ADDENDUM NO. 2

DATE OF ISSUANCE:	April 22, 2024
PROJECT:	2024 Addition and Renovations North Harrison Elementary School 1115 W. Whiskey Run Road Ramsey, IN 47166
OWNER:	North Harrison Community Schools
ARCHITECT'S PROJECT NO.:	23-228.001
ORIGINAL BID ISSUE DATE:	April 03, 2024

SHEET TITLE
PARTIAL FIRST FLOOR PLAN -
LIGHTING - AREA A

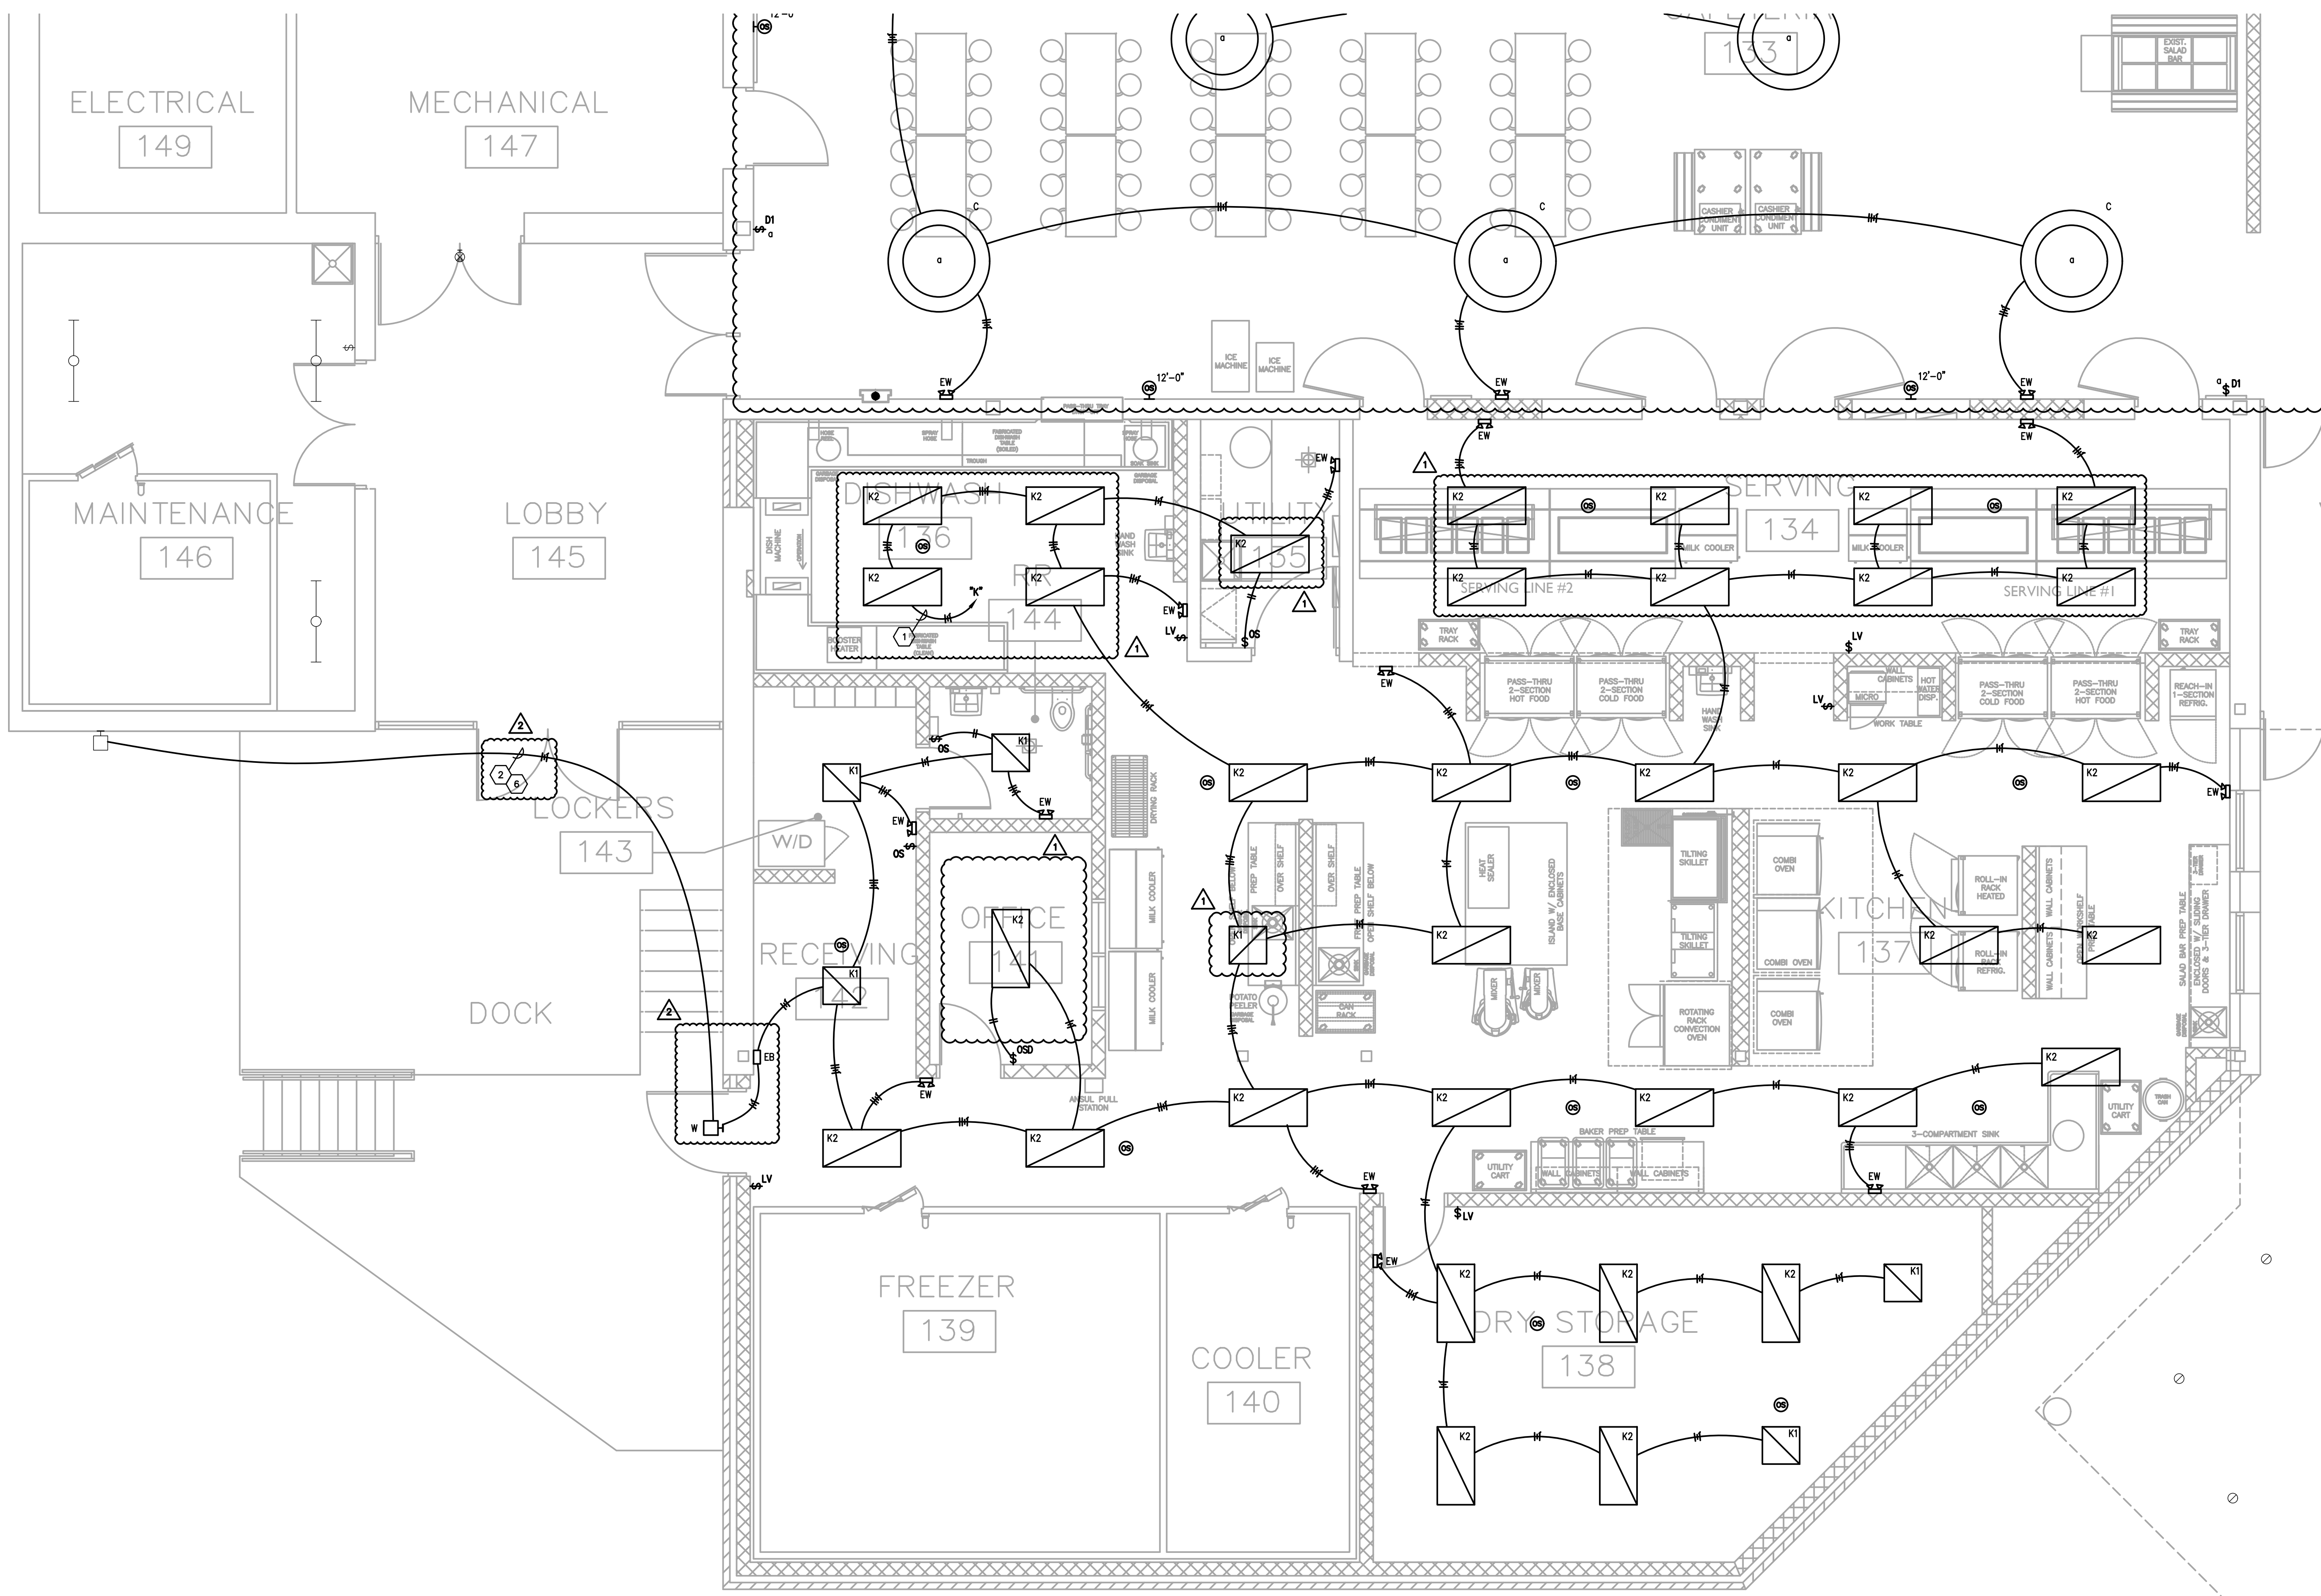
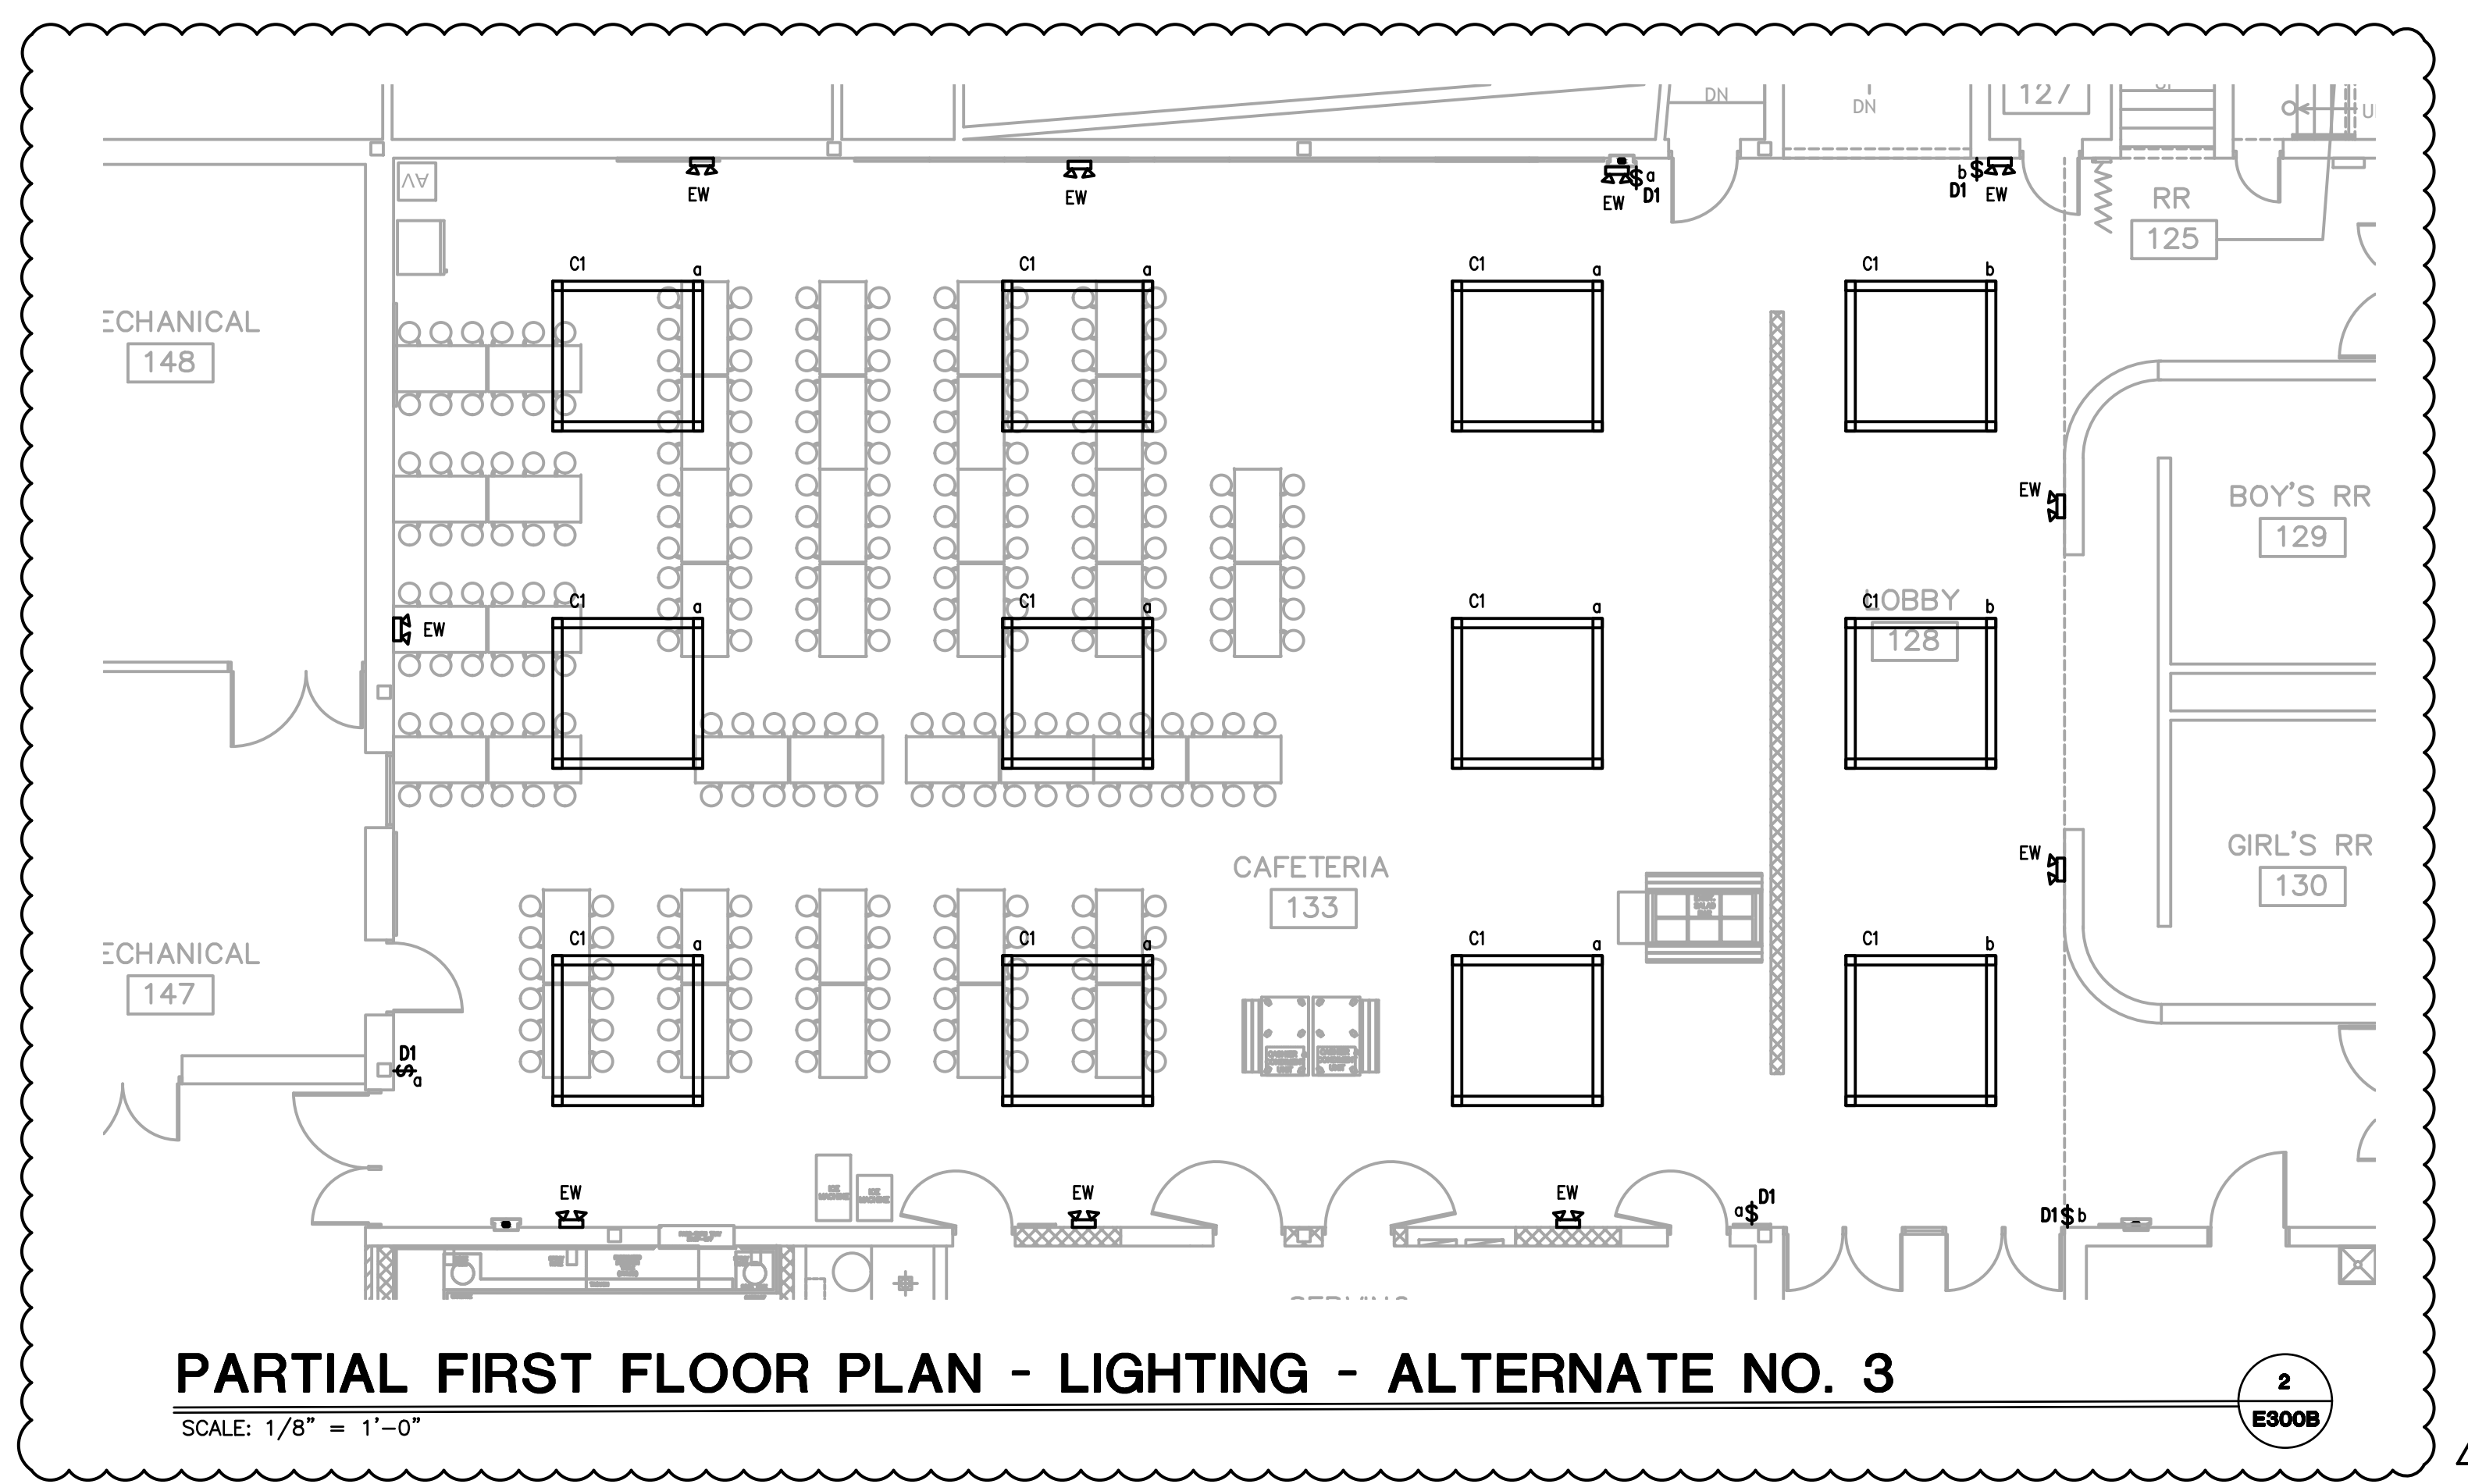
ADD-2 Item No. D-15 - Exterior Lighting Controls

Circuit exterior lighting fixture "W" to fixture "EB" in Receiving 142. New exterior lighting fixture shall be controlled by existing exterior lighting controls through existing exterior light fixture indicated on plans.
